Summary of the Office Action

FIG.1

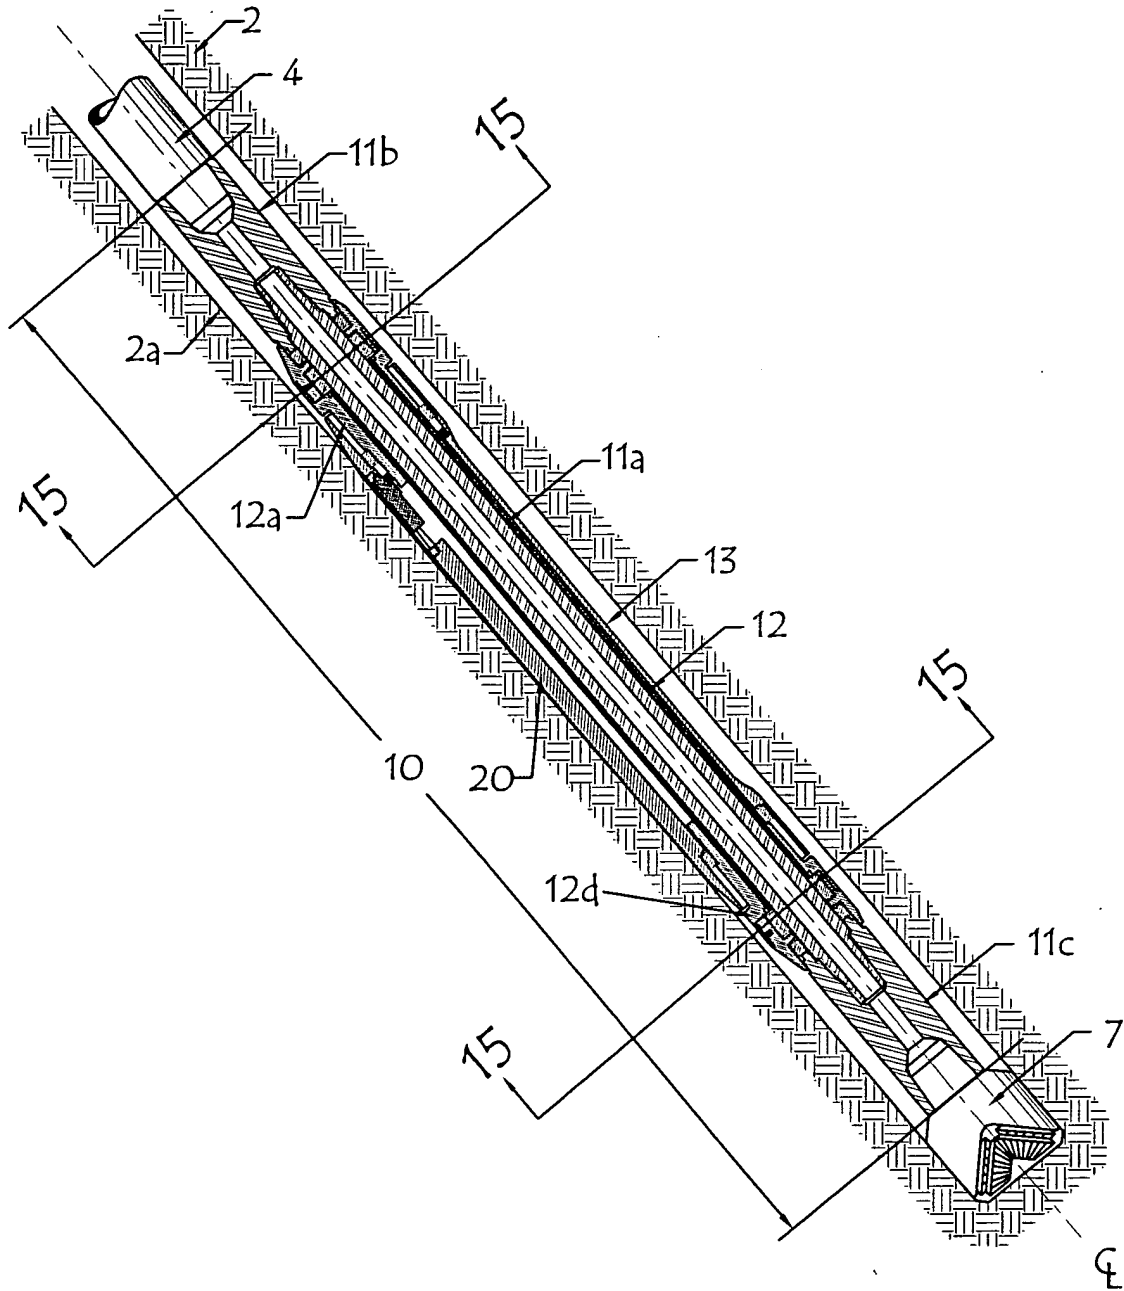
The Examiner objected to drawings and in particular to Figures 1, 3, 5A and 5B, 6, 9, 10, 11 and 14. (It should be noted that all of the figures were submitted as informal drawings and technically none of the figures met the standards of the Office.)

The Examiner objected to Figures 1,3,6,9 and 14, stating that, "all have section lines designated as capital letters (usually A-A and B-B). Each of these section lines should be designated with a different Roman or Arabic reference. These changes should be reflected in the Specification as well as the drawings."

The Examiner further objected to Figure 1, stating that, "cross sections A-A and B-B are shown but there are no figures associated with these cross sections."

FIG. 5A

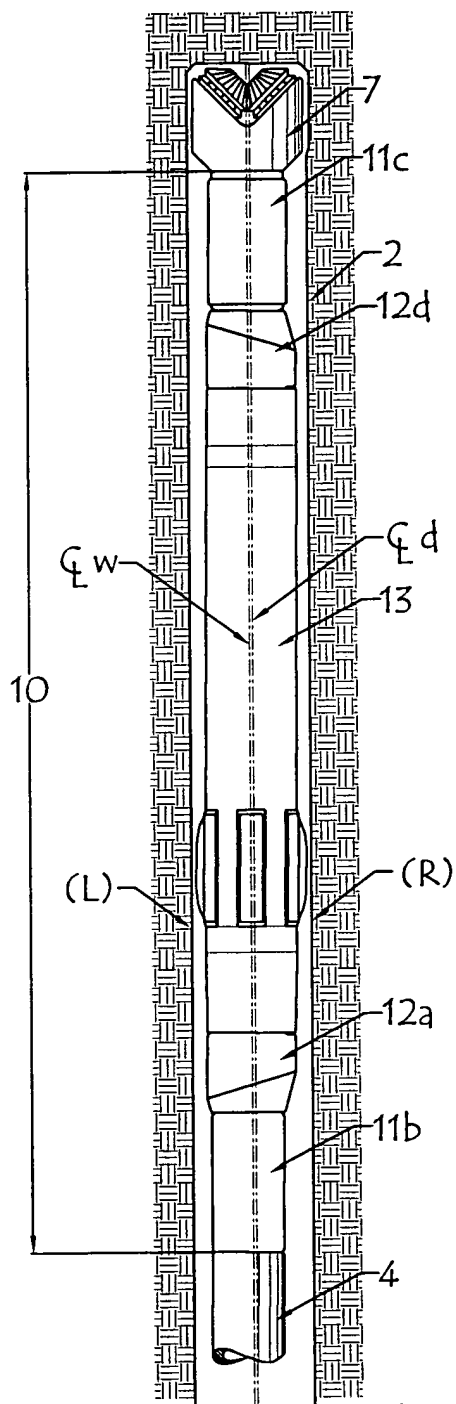
The Examiner objected to Figures 5A and 5B stating that, "although the device is described as turning in Figures 5A and 5B, the drill bit is shown as centered in the well bore and not biased in the direction of the turn, as described in the specification."

FIG. 6

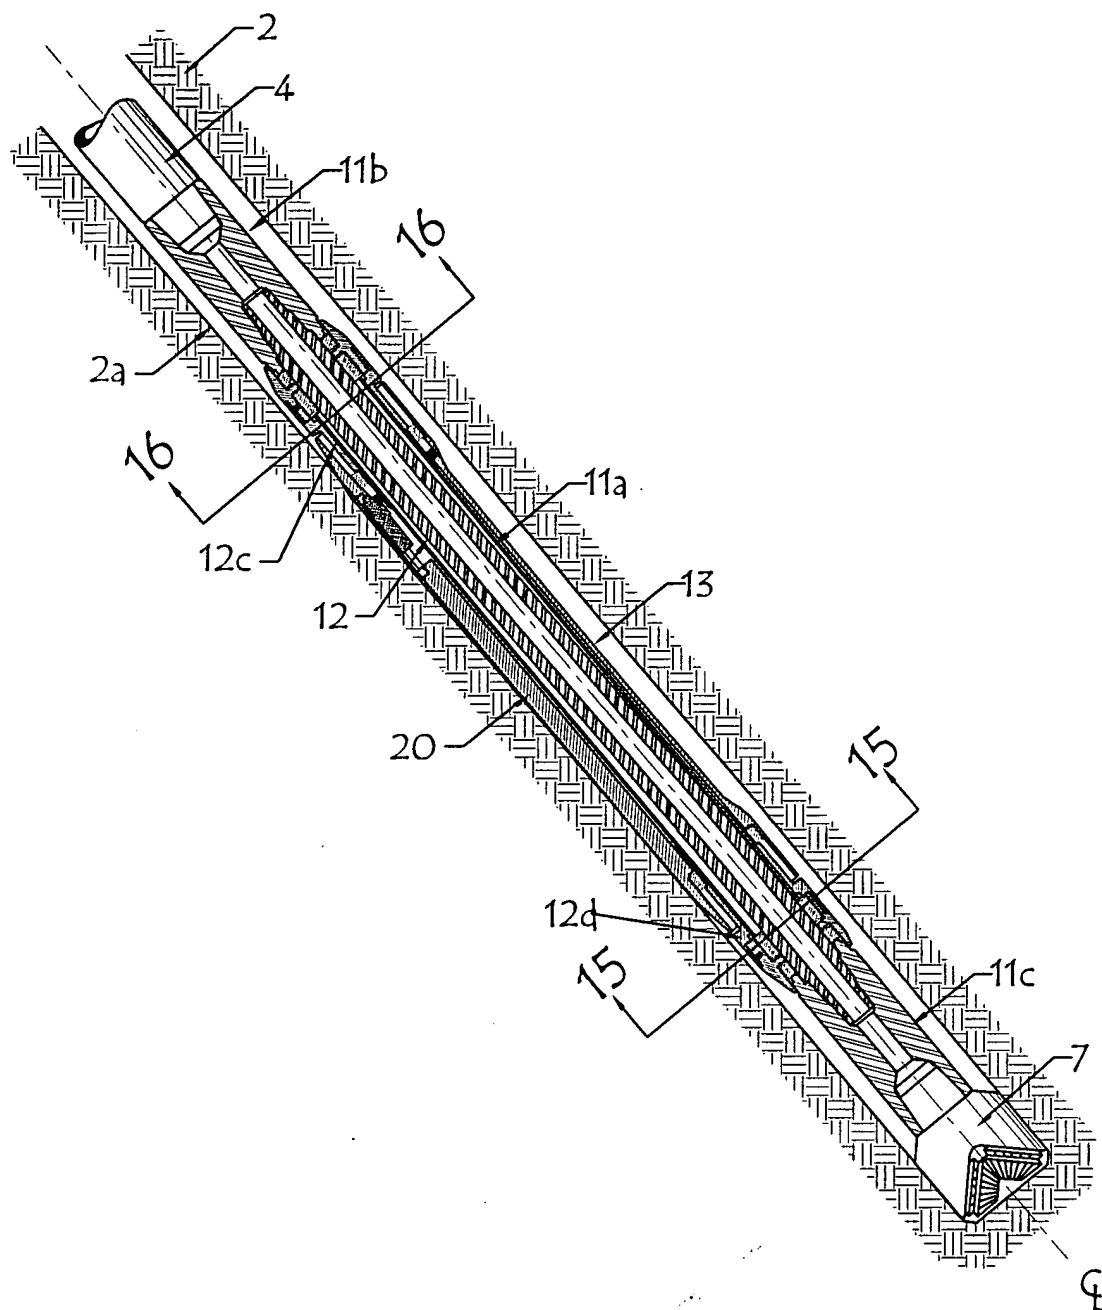
The Examiner also objected to Figure 6 stating essentially that, "Figure 6 is identical to Figure 1." The Examiner continued in his objection stating that, "Page 19 of the specification indicates that 'To avoid unnecessary repetition, the same reference numerals have been used (in Figure 6) as for Figure 1.' This is not appropriate unless the components represented by the same reference numbers are identical -- and in this case, the components are not identical. If the components were identical, the figures would be redundant, and it would be appropriate to delete one of the figures."

FIG. 10

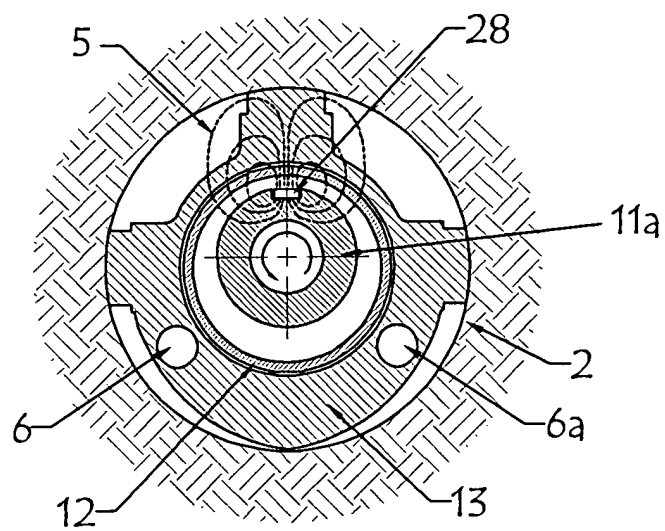
The Examiner objected to Figure 10 because no crosshatching was shown for the inner sleeve in Figure 10. The Examiner continued his objection to Figure 10 stating that, "Reference
